BROWNS FERRY NUCLEAR PLANT (BFN) – UNITS 1, 2, AND 3 – TECHNICAL SPECIFICATIONS (TS) CHANGES TS-418 AND TS-431 – EXTENDED POWER UPRATE (EPU) – RESPONSE TO ROUND 23 REQUEST FOR ADDITIONAL INFORMATION (RAI) REGARDING STEAM DRYER SIGNAL PROCESSING (TAC NOS. MD5262, MD5263, AND MD5264)

**TENNESSEE VALLEY AUTHORITY
BROWNS FERRY NUCLEAR PLANT (BFN)
UNITS 1, 2, AND 3**

**TECHNICAL SPECIFICATIONS (TS) CHANGES TS-431 AND TS-418
EXTENDED POWER UPRATE (EPU)**

**RESPONSE TO ROUND 23 REQUEST FOR ADDITIONAL INFORMATION (RAI)
REGARDING STEAM DRYER SIGNAL PROCESSING**

Figure EMCB.202/163-3a. Cross Spectra for BFN1 main steam line A: magnitude (top) and phase (bottom) for CLTP (black) and LF (blue) conditions, with EIC removed.

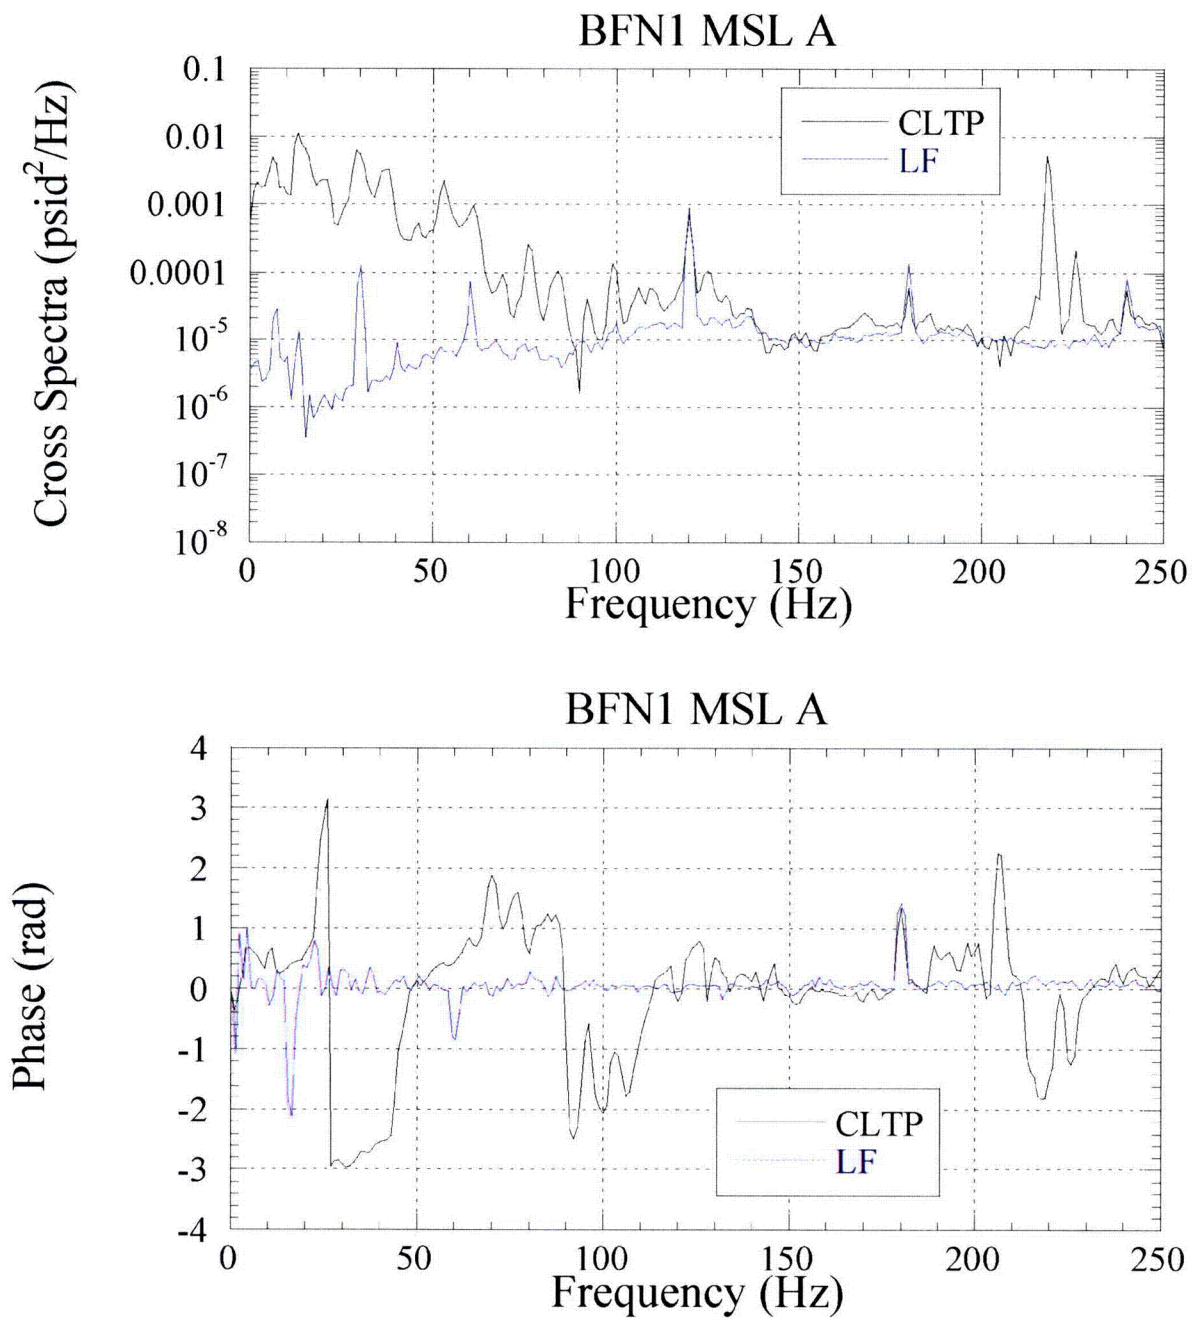
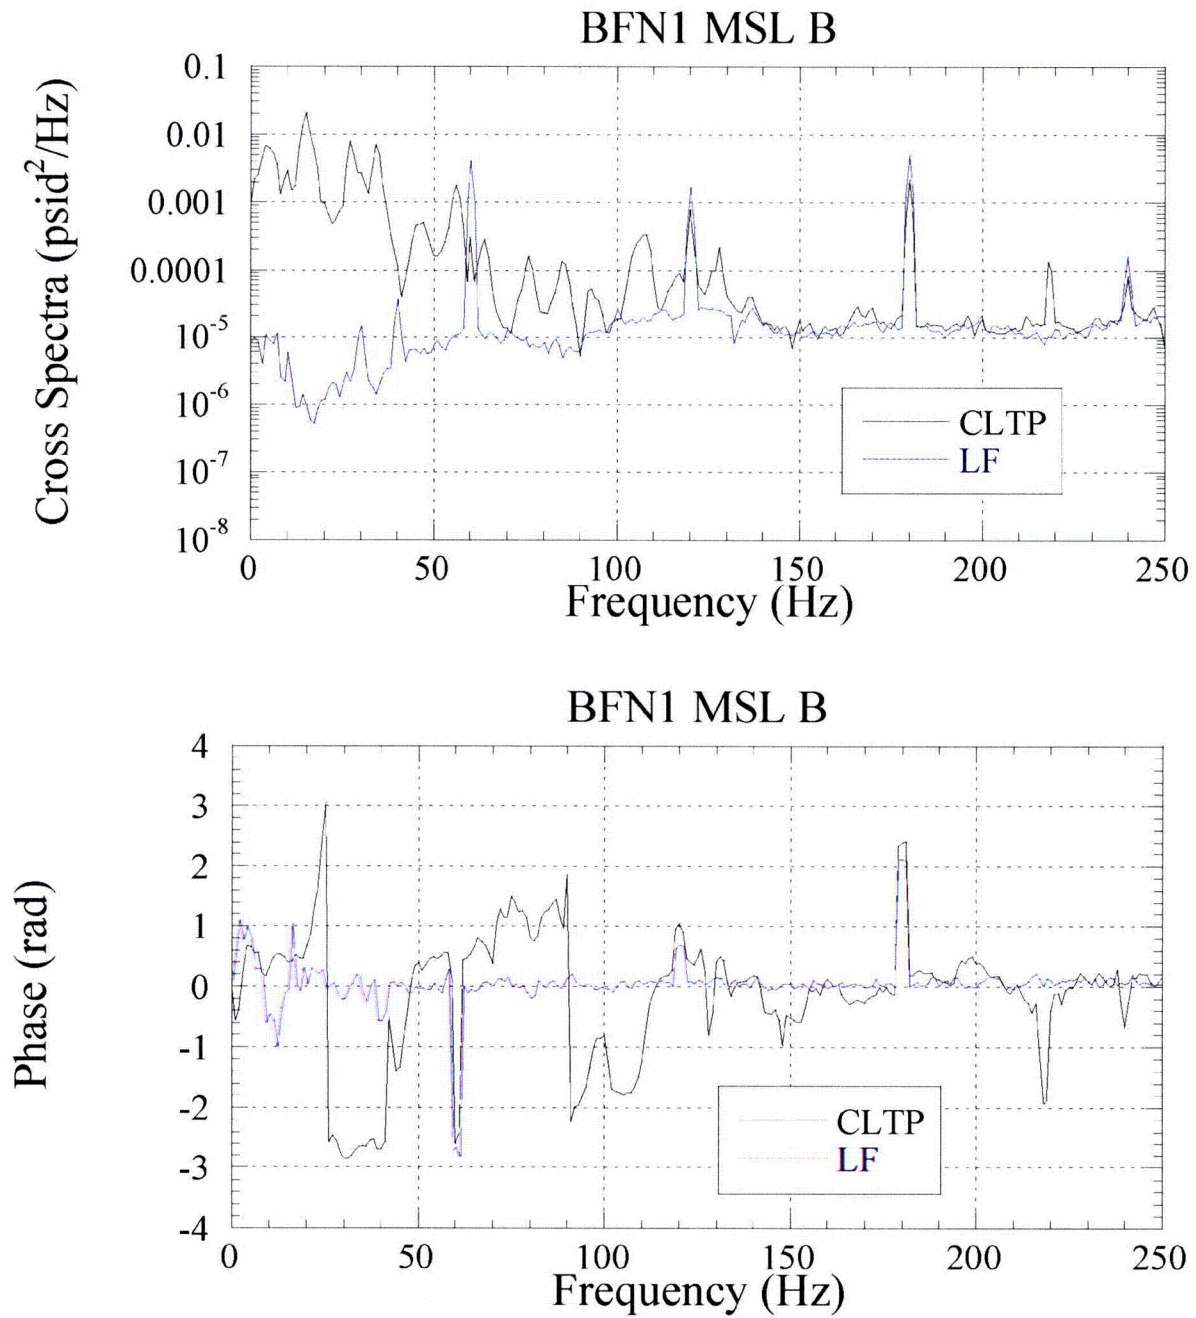
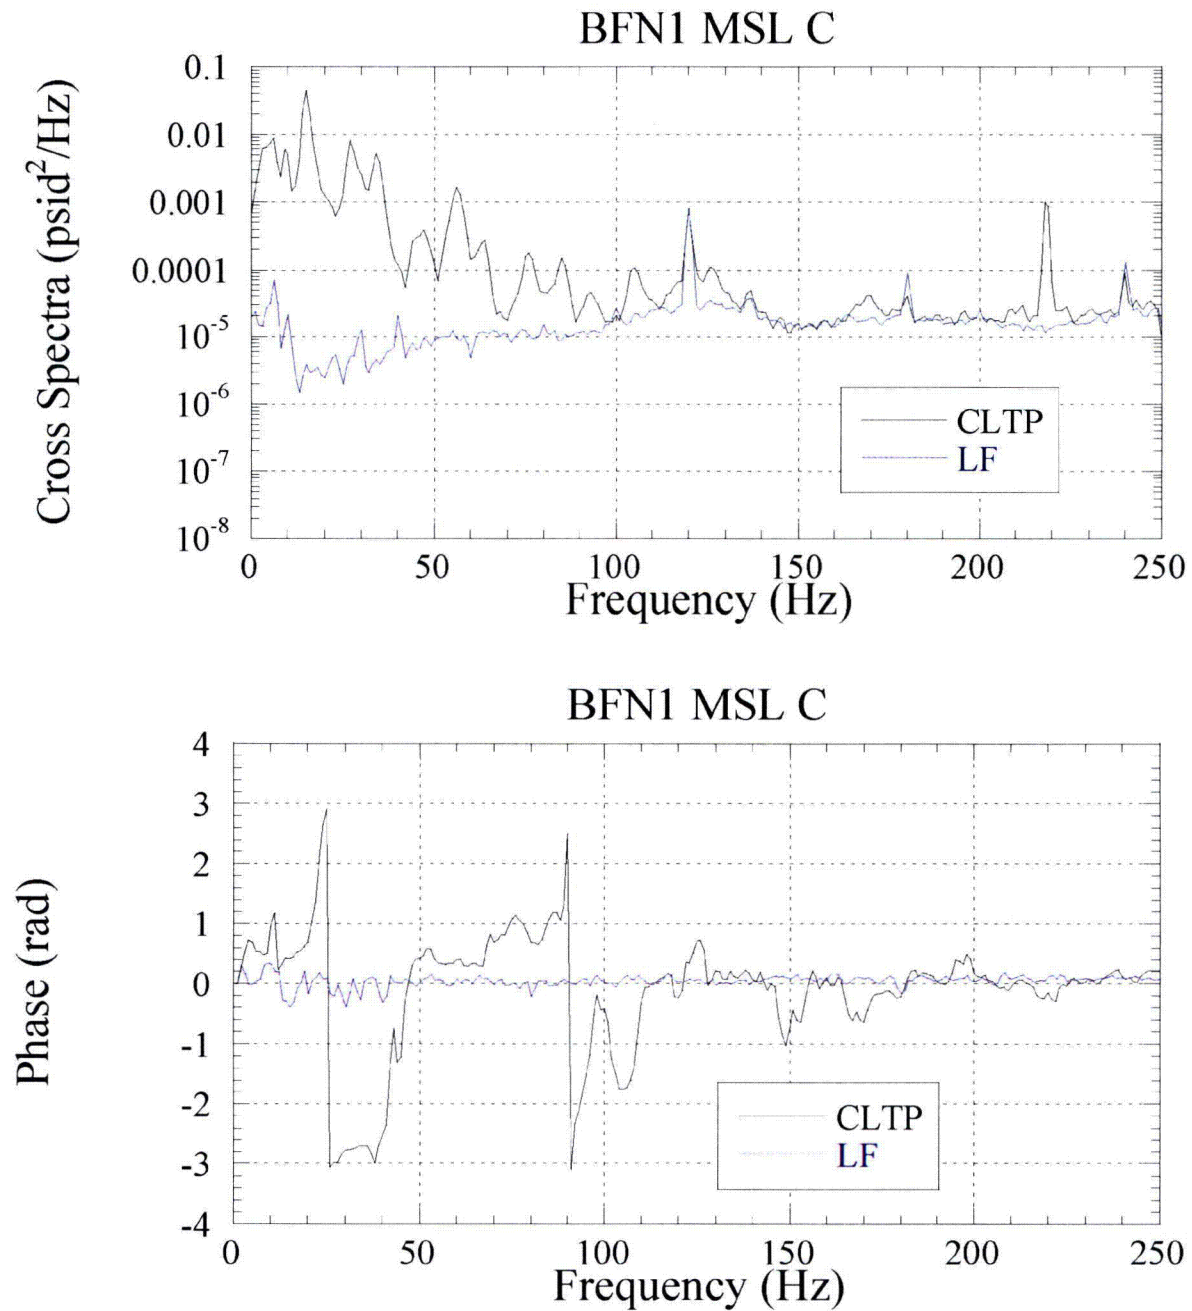
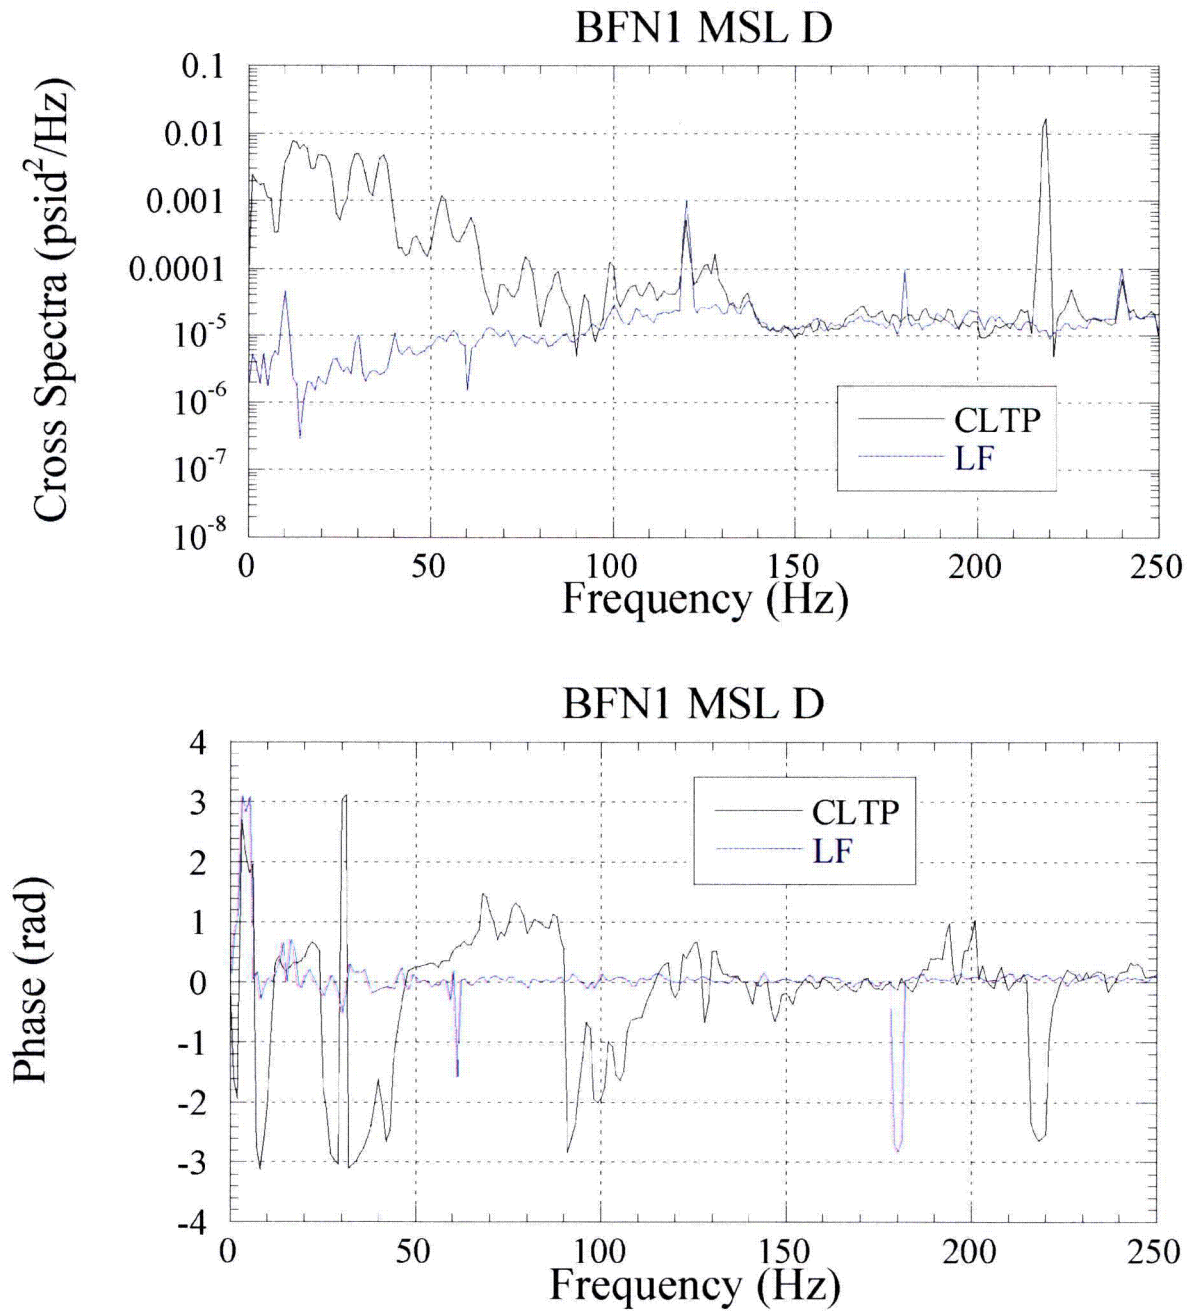
where G_{12} is the cross-spectrum between the two signals, and G_{11} and G_{22} are the autospectra of the individual signals. Explain how G_{12} is modified after using EIC signals and notch filters prior to being used in the coherence calculation. This explanation should include how both the magnitude and phase of G_{12} are modified.

In Figures EMCB.202/163-3a through 3d the cross spectra magnitude and phase after EIC subtraction (scaling) for CLTP and LF data are shown.
